## PIC18C601/801 Rev. C0 Silicon/Data Sheet Errata

The PIC18C601/801 parts you have received conform functionally to the Device Data Sheet (DS39541A), except for the anomalies described below.

## FIGURE 1: INTERRUPT LOGIC (EXCERPT)

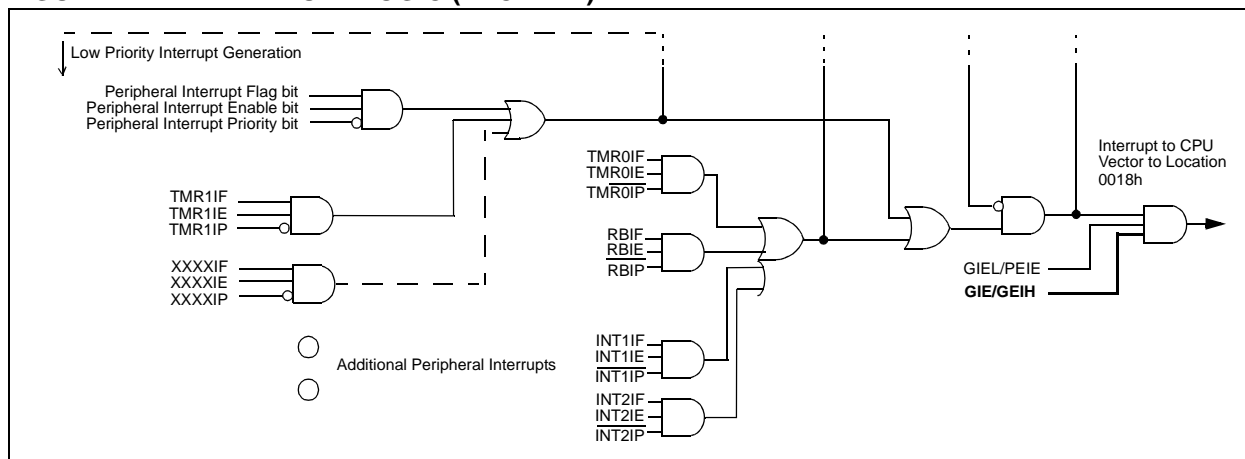
Also, the interrupt logic funnel shown in Figure Figure 1 of the Device Data Sheet is amended with the addition of a GIE/GIEH control line, as shown in Figure 1 (new material in **bold line**).

**FIGURE 2: PIC18LC601/801 VOLTAGE-FREQUENCY GRAPH (INDUSTRIAL)**

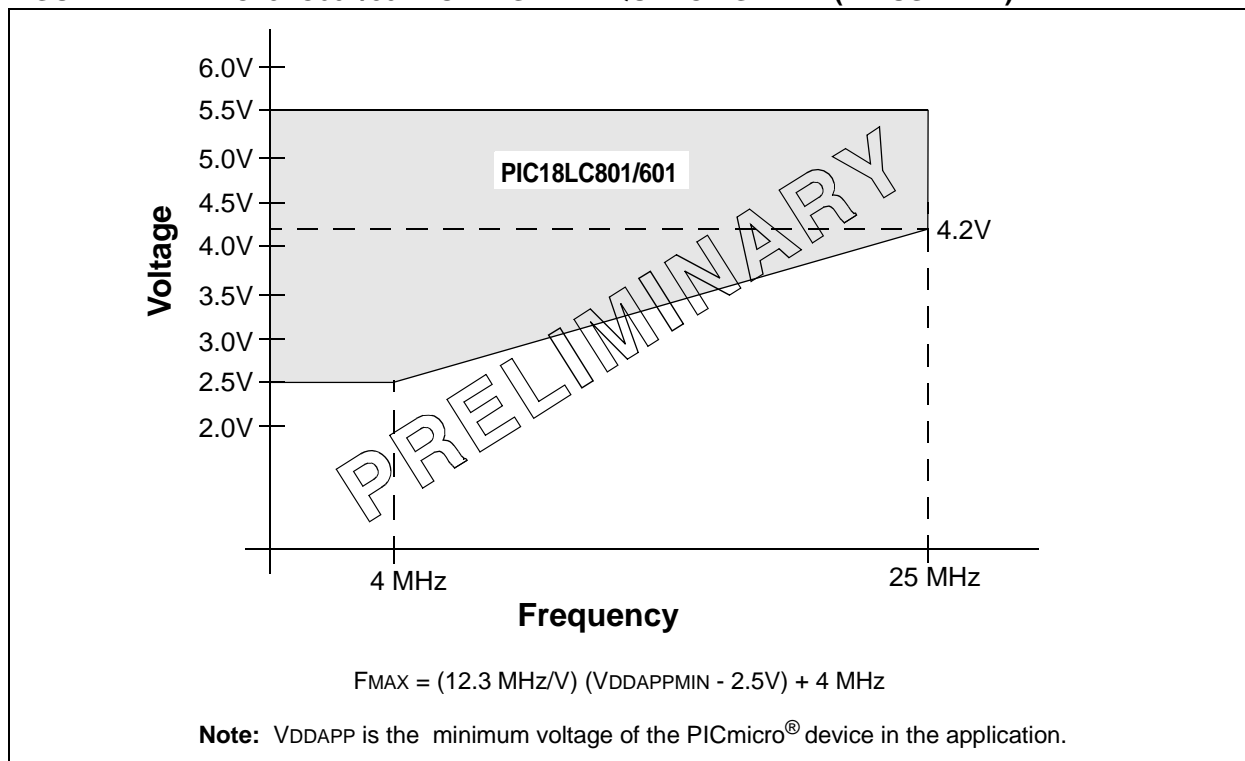
The minimum value for parameter specification number D001 (VDD) for extended voltage range devices has changed from 2.0V. The new value is shown in Table 3.

Because of this change, the voltage vs. frequency graph for extended voltage range devices has been modified. Figure 22-2 of the Device Data Sheet is replaced with Figure 2, below. This also clarifies that the graph refers to extended voltage range ("LC") devices.

Param No	Symbol	Characteristic		New Specification	Data Sheet Specification	Units
				Min	Min	
D001	VDD	Supply Voltage	PIC18LC601/801	2.5	2.0	V
